Bid Addendum No. 1

January 13, 2025

Nyack Union Free School District – Boiler Replacements

CSArch Project No. 226-2301

Sheet No.:
**HTA
M102**

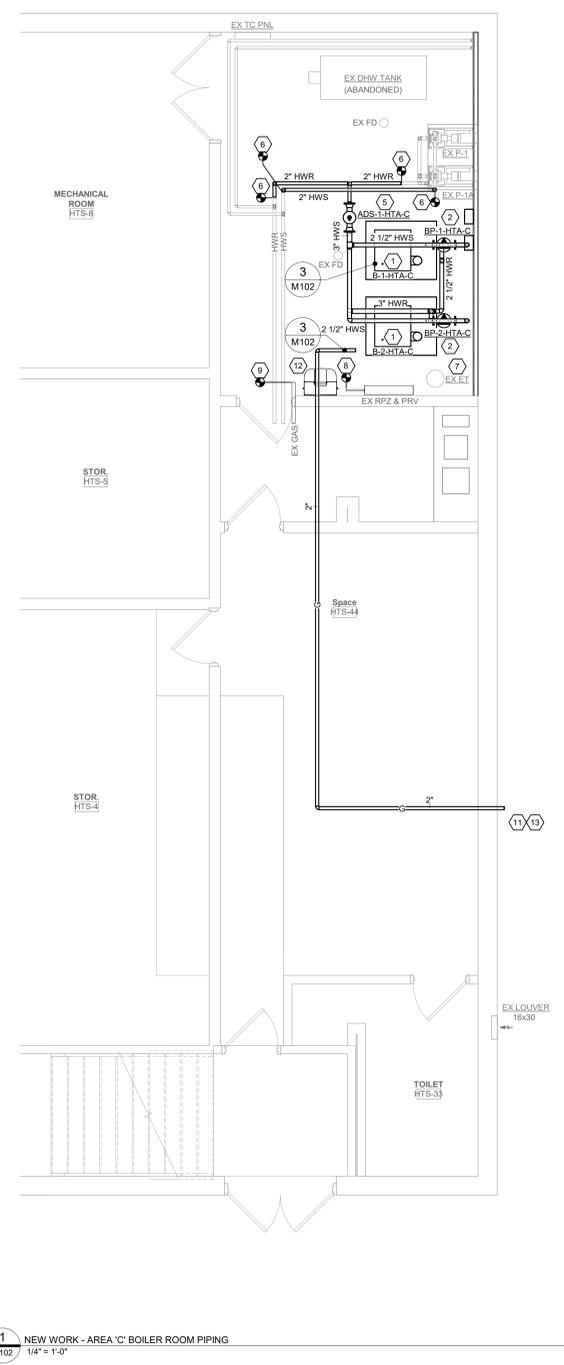
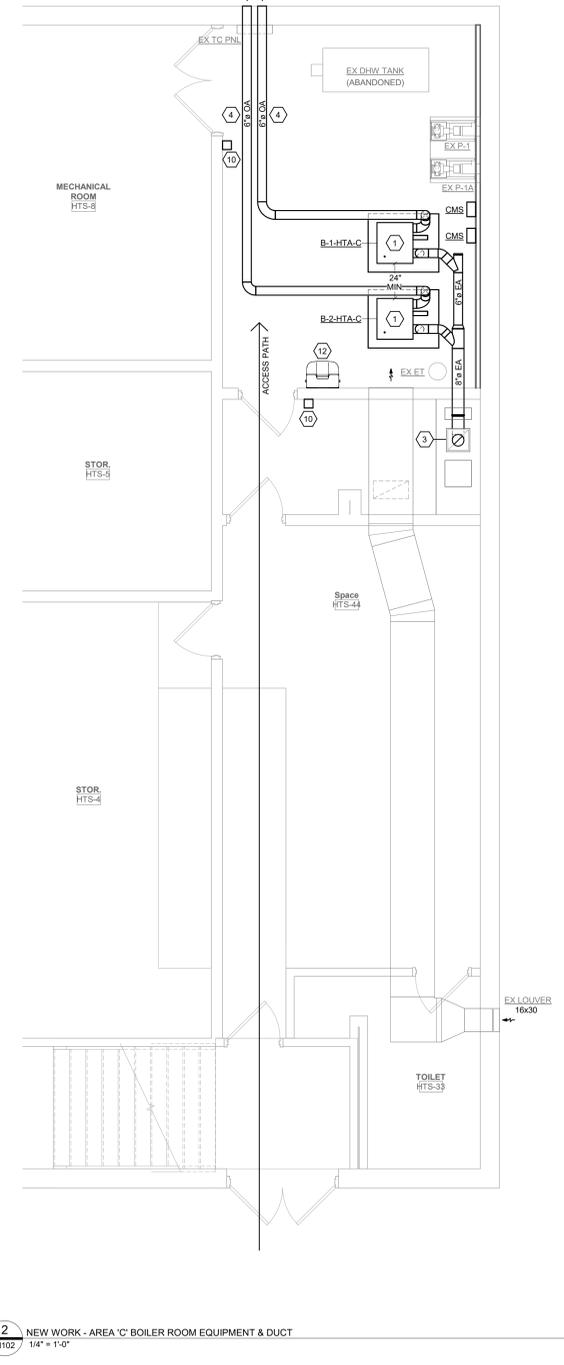
5. HTA M102, Note 3. The referenced note reads in part, "Providing boiler flue in existing chimney." Does this mean a chimney liner? Or is there access to install the actual flue piping in existing chimney? **RESPONSE: Provide single wall breaching system per specification 235133 within existing chimney. Breaching system exposed in boiler room shall be double wall.**

- PROVIDE BOILER CIRC. PUMP AS SCHEDULED INCLUDING ALL ASSOCIATED PIPING, VALVES, INSULATION, CONTROLS, HANGERS AND SUPPORTS.
 - PROVIDE 6" DIA. DOUBLE WALL PREFABRICATED CHIMNEY FLUE FROM BOILER TO COMBINED 6" DIA. VENT SYSTEM. ALL BREACHING SHALL BE PER SPECIFICATION 235133. PROVIDE SINGLE WALL BREACHING IN EXISTING CHIMNEY. PROVIDE ALL NECESSARY ACCESSORIES INCLUDING DRAIN, RAIN CAP, FLASHING AND SUPPORTS FOR A COMPLETE VENT SYSTEM.
